Color code:

General comments:

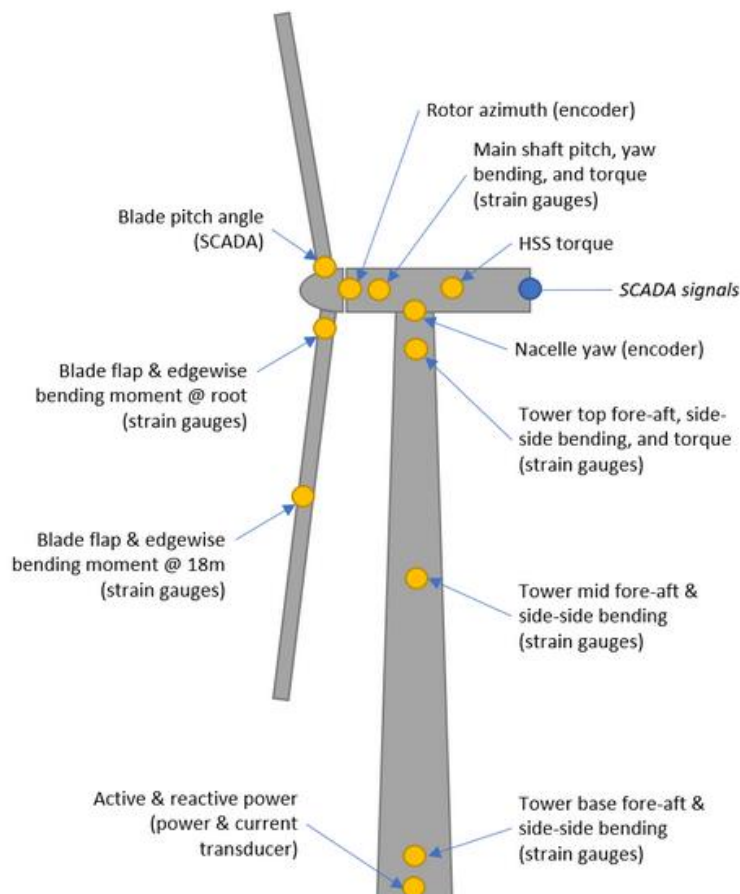
- -p3 section 2 p77/78 A description of the test set-up of the experiment including turbine, instrumentation and visuals would help the reader. What is the rated wind speed? Part of section 3.1 could be moved here. (RC1)

Yes, a graphic showing the relevant instrumentation has been added as the new Figure 4. We have elected to put this figure in Section 3 because our goal was to wait until Section 3 to introduce the main experimental campaign. We have instead added a line in Section 2 to point the reader ahead to Section 3 for full details on the turbine setup.
